1st Further Information

**Proposed Temporary Open Storage of Construction Material and Machinery with
Ancillary Facilities for a Period of 3 Years and Associated Filling of Land
in “Agriculture” Zone, Various Lots in D.D. 82, Ta Kwu Ling, New Territories**

(S.16 Planning Application No. A/NE-TKL/763)

Responses-to-Comments

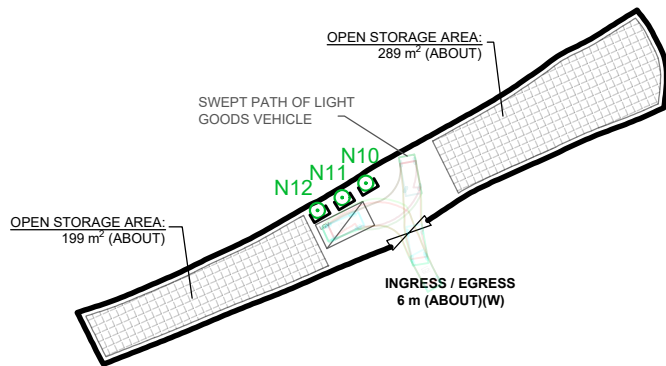
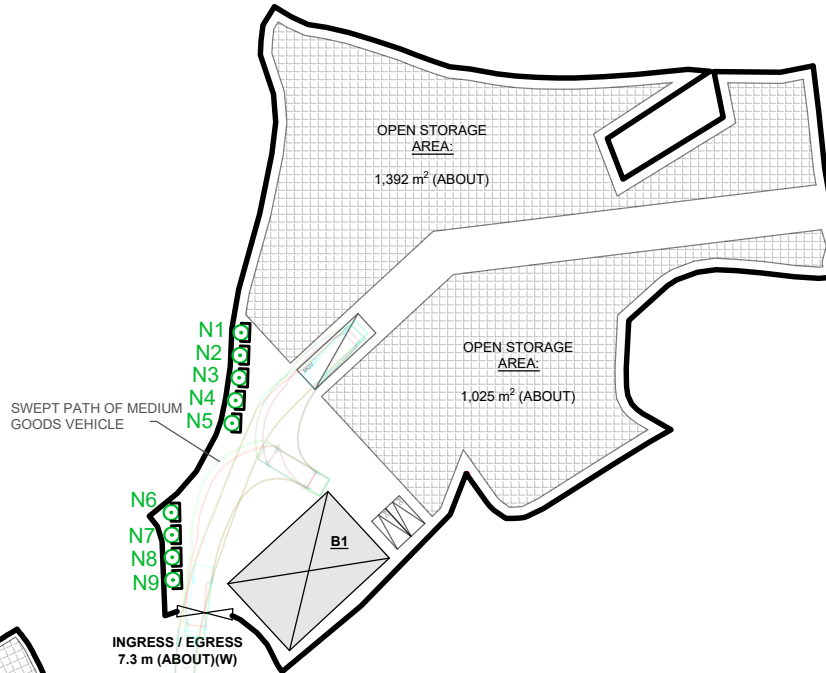
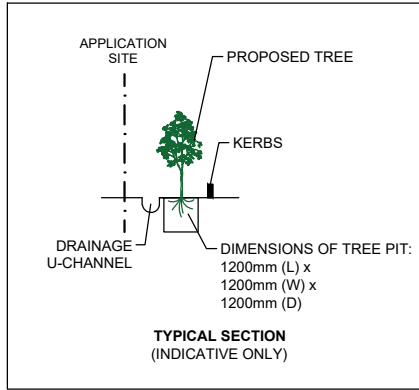
2. Comments of the Chief Town Planner/Urban Design and Landscape, Planning Department (CTP/UD&L, PlanD)		
(a)	<u>Landscape Observations and Comments</u> With reference to the aerial photo of 2023, the site is located in an area of rural inland	According to our site visit conducted in July 2024, no old and valuable tree or protected

<p>(b) <u>Detailed Comments/ Advisory Comments</u></p> <p>The applicant is advised to provide basic information (e.g. species, size, general conditions and tree photos) on existing trees within and along the site boundary, proposed tree treatments and mitigation measures for TPB’s consideration.</p> <p>The applicant should be advised that approval of the application does not imply approval of tree works such as pruning, transplanting and felling. The applicant is reminded to seek approval for any proposed tree works from relevant authority prior to commencement of the works.</p>

<p>plains landscape character comprising of farmlands, temporary structures, vegetated areas, clusters of tree groups, and woodland within the “GB” zones to the north and southeast. The proposed use is not compatible with the surrounding environment. There is a concern that approval of the application may alter the landscape character and degrade the landscape quality of the surrounding area, where the “Green Belt” zone is in close proximity to the north and immediate southeast of the site.</p> <p>Based on our site records taken on 2.7.2024, the site is fenced off and mainly covered by wild grasses. Some trees of undesirable and common species, e.g. Musa spp. (蕉屬) are observed within the site. Since tree information, proposed tree treatment and landscape treatment/mitigation measures are not provided, potential impact on the landscape resources cannot be reasonably ascertained.</p>	<p>species has been identified at the Site. Due to the proposed hard-paving works for site formation of structures and circulation purpose, all existing trees will be affected, and it is not proposed to retain any of the existing trees within the Site.</p> <p>A landscape proposal is submitted by the applicant to provide landscape mitigation measures for the proposed development (Annex I). <u>12</u> new trees (N1 to N12) are proposed to be planted along the northwest and southwest periphery boundary of the Site as indicated on plan, to minimise adverse visual impact to the adjoining receivers. All these new trees within the Site will be maintained by the applicant during the planning approval period.</p>

DRAWING NUMBER
 FIGURE 3

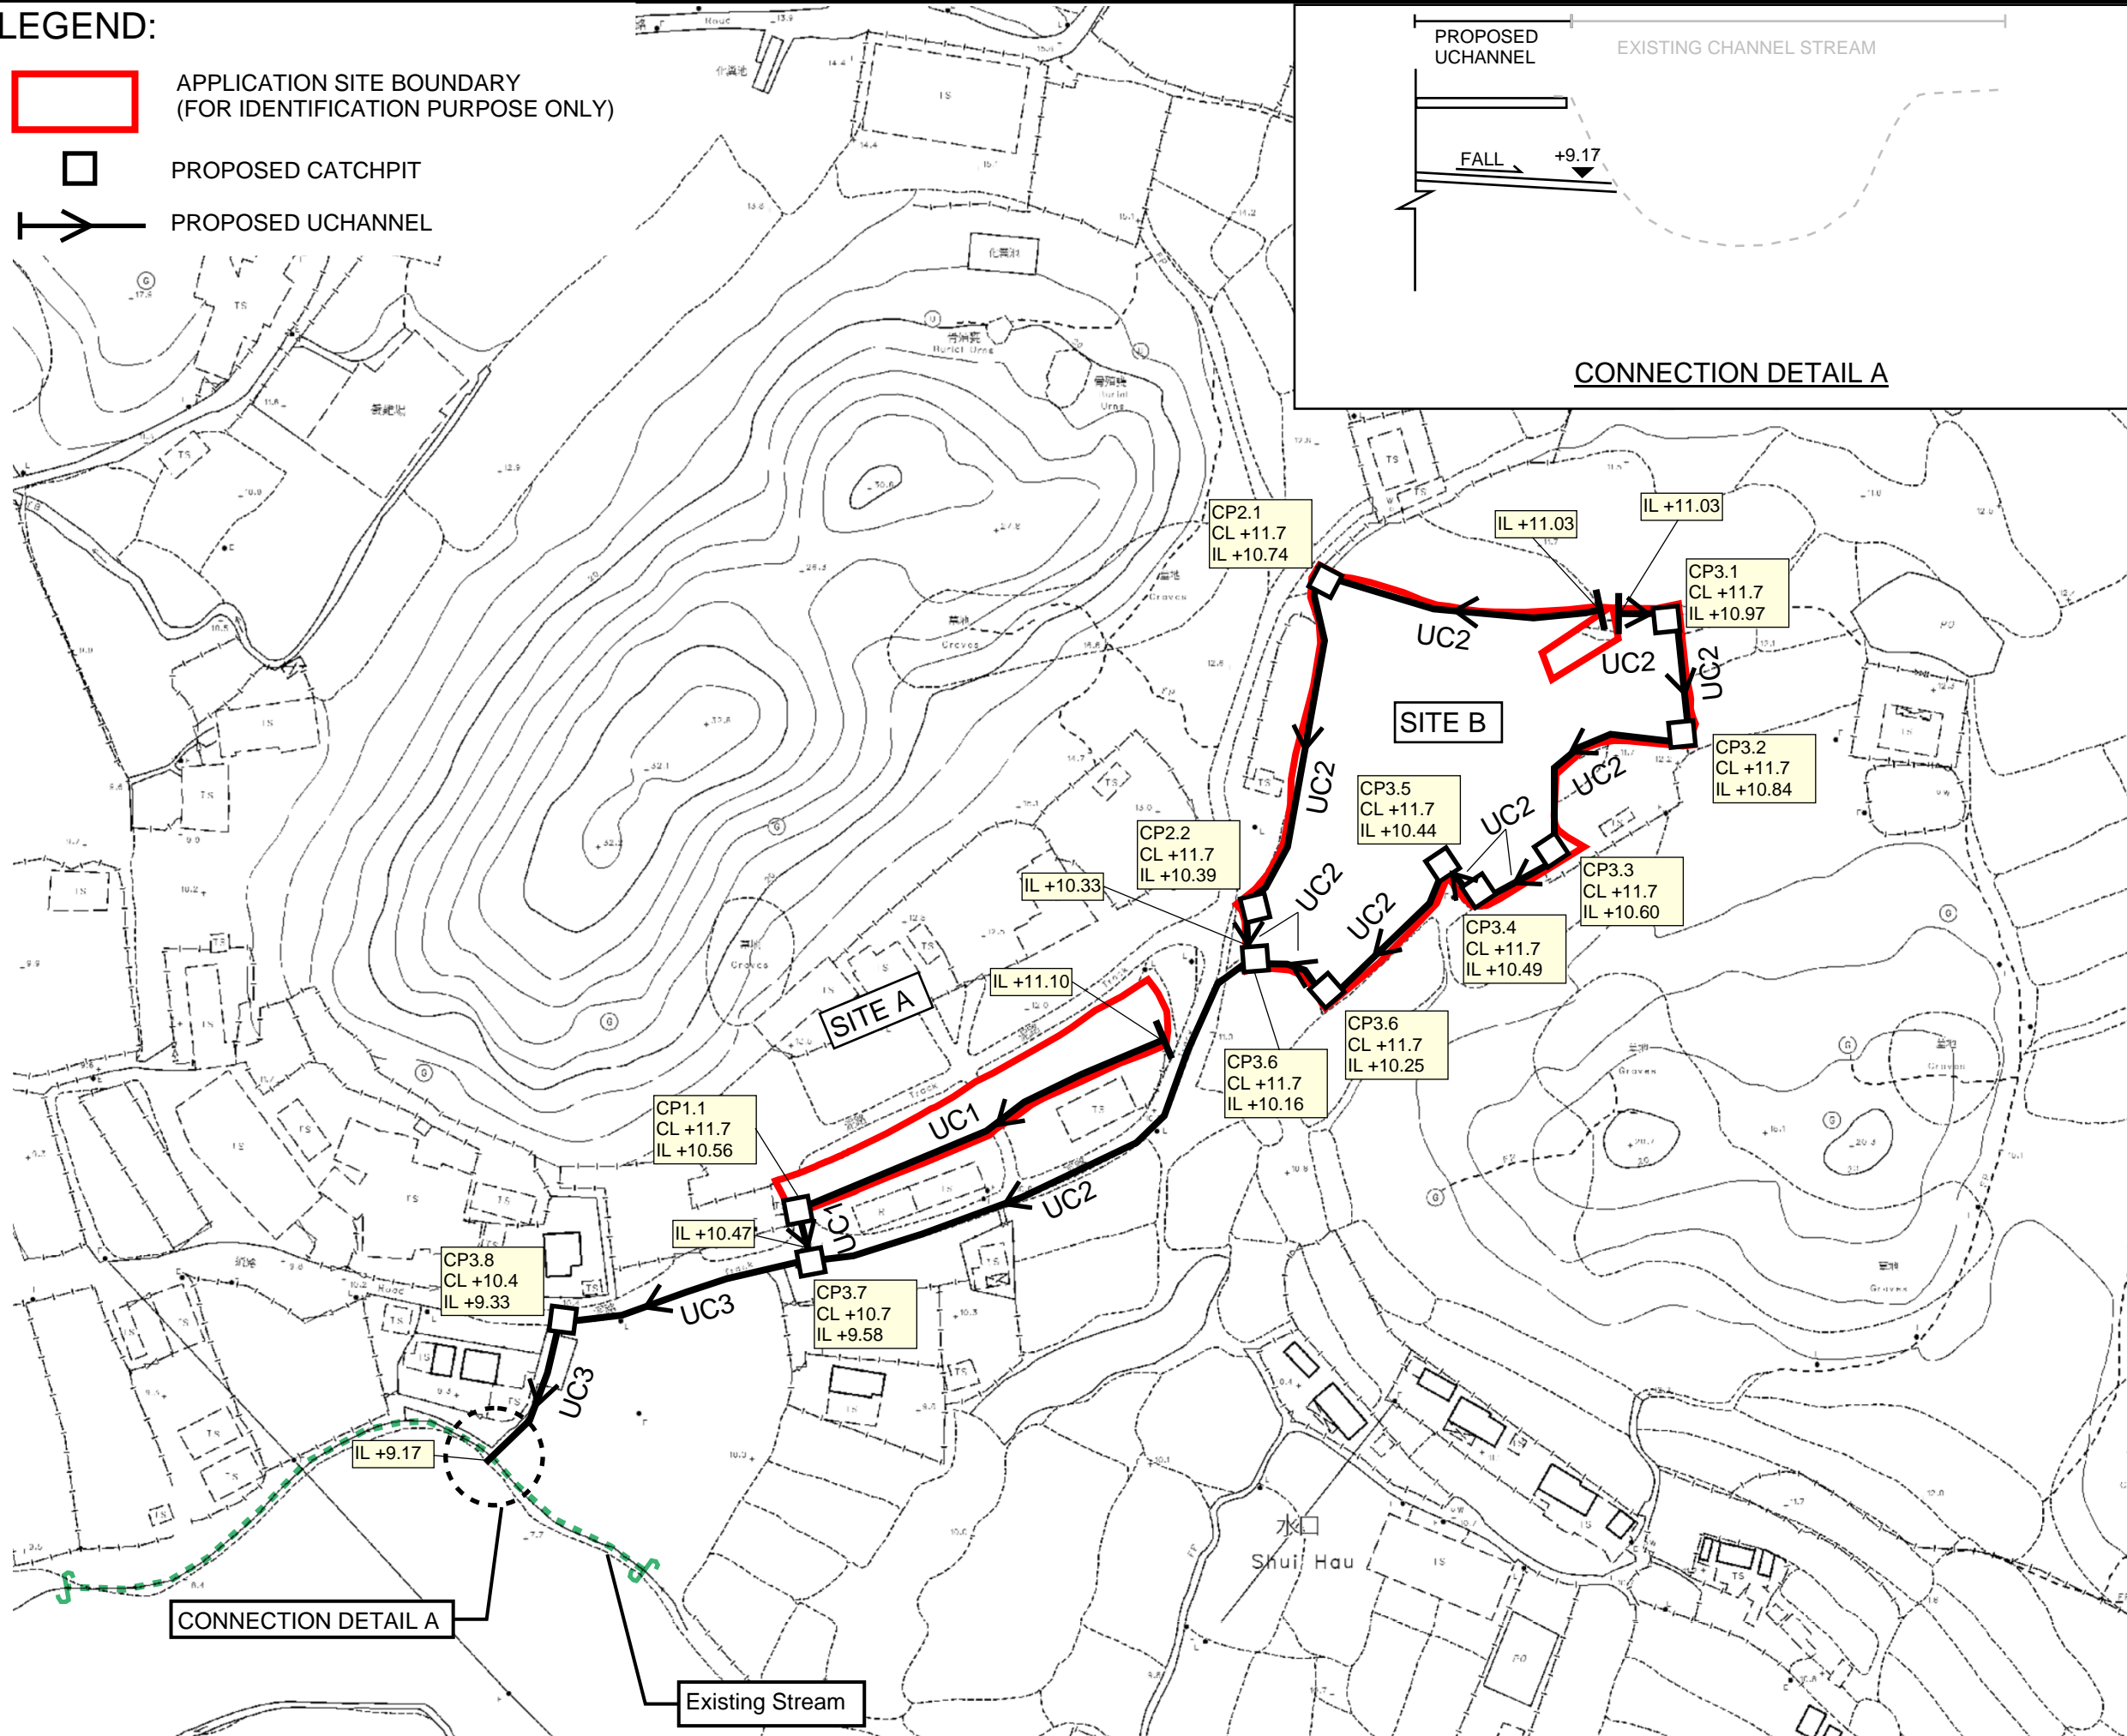
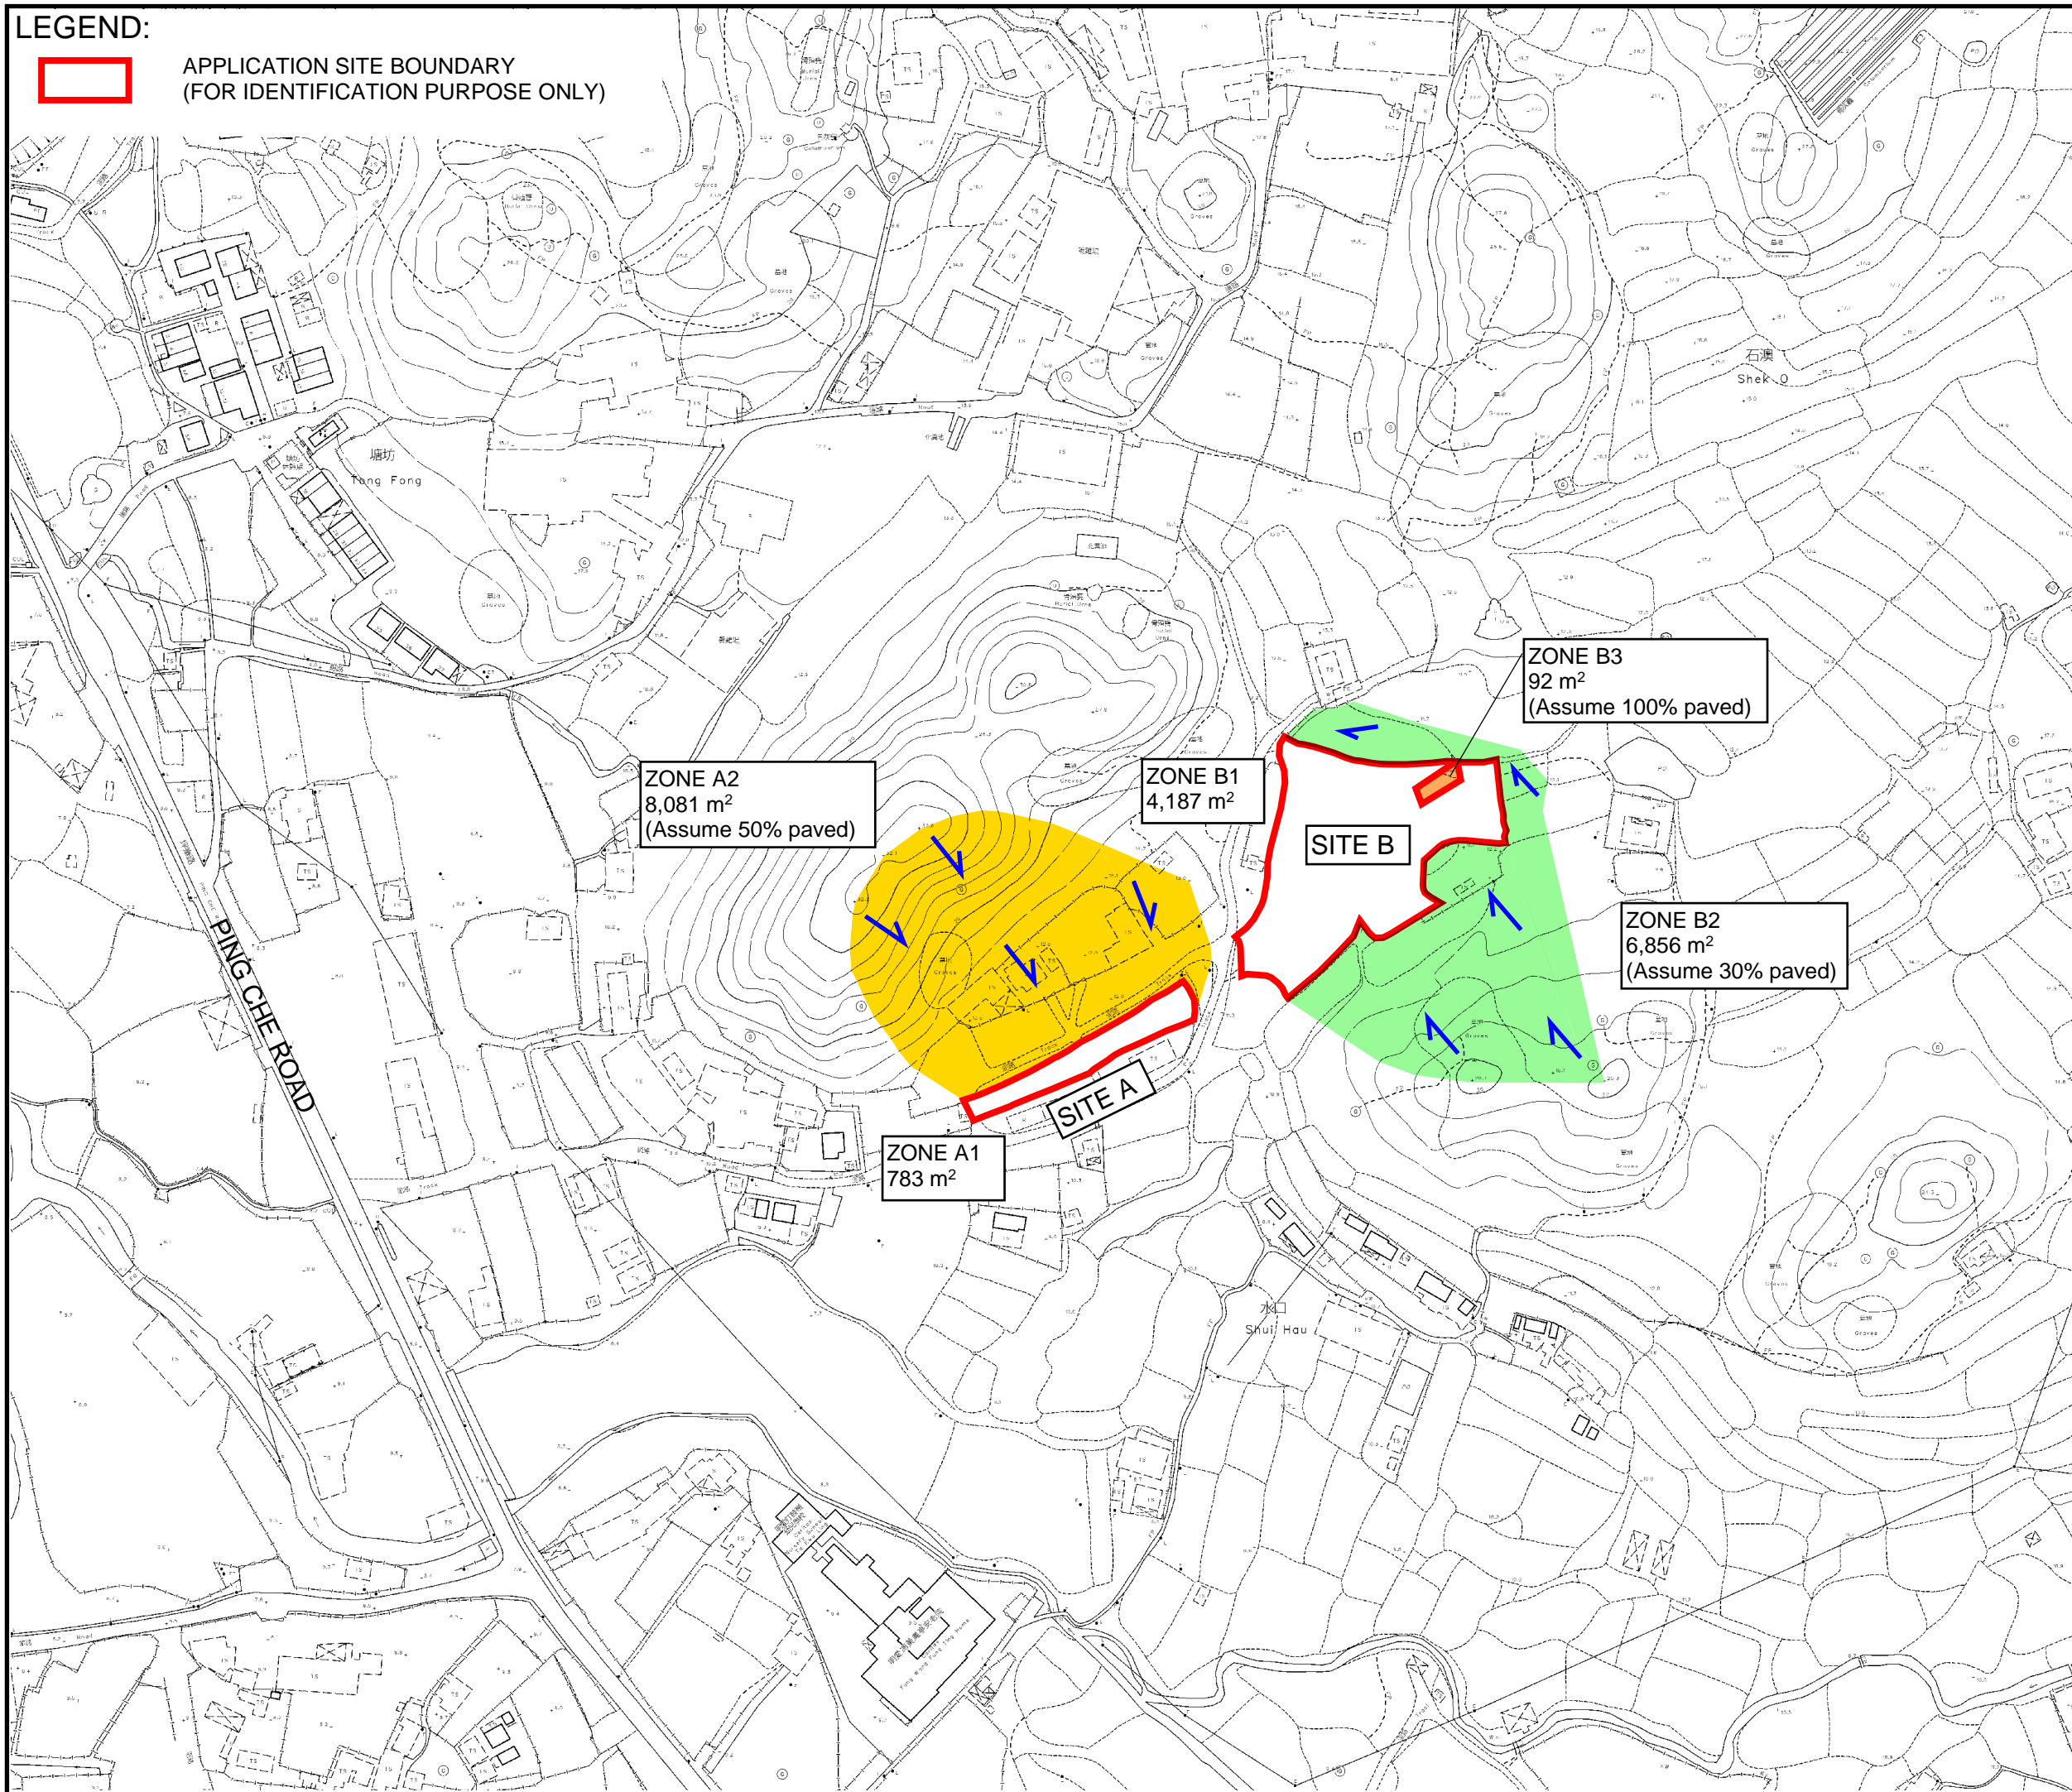
4. Comments of the Chief Engineer/Mainland North, Drainage Services Department (CE/MN, DSD)		
(a)	<p>Flooding complaints have been recorded based on our records. It is revealed that the area adjoining the application site is subject to overland flows and/or regular flooding. Unless the applicant can submit satisfactory drainage proposal to mitigate the flooding susceptibility of the area to my satisfaction, I do not support the application.</p> <p>The site is in an area where public sewerage connection is not available. EPD should be consulted regarding the sewage impact assessment and sewage treatment/disposal facilities for the proposed development.</p>	<p>A drainage proposal is prepared by the applicant to mitigate the flooding susceptibility of the area (Annex II). According to the result of the drainage proposal, with the implementation of the proposed drainage system, adverse drainage impact to the surrounding area is <u>not</u> anticipated.</p>

- 4.1.1 Proposed U-channels are designed for collection of runoff within and near the Development Site. Please refer to the **Figure 4** for proposed catchment plan. The U-channels from both site A and site B are proposed to be connected and discharged to existing stream at the south. The design calculations of proposed UChannels are shown in **Appendix A**.
- 4.1.2 The alignment, size, gradient and details of the proposed drains are shown in **Figure 3**.
- 4.1.3 The reference standard drawings of drains are shown in **Appendix C**.
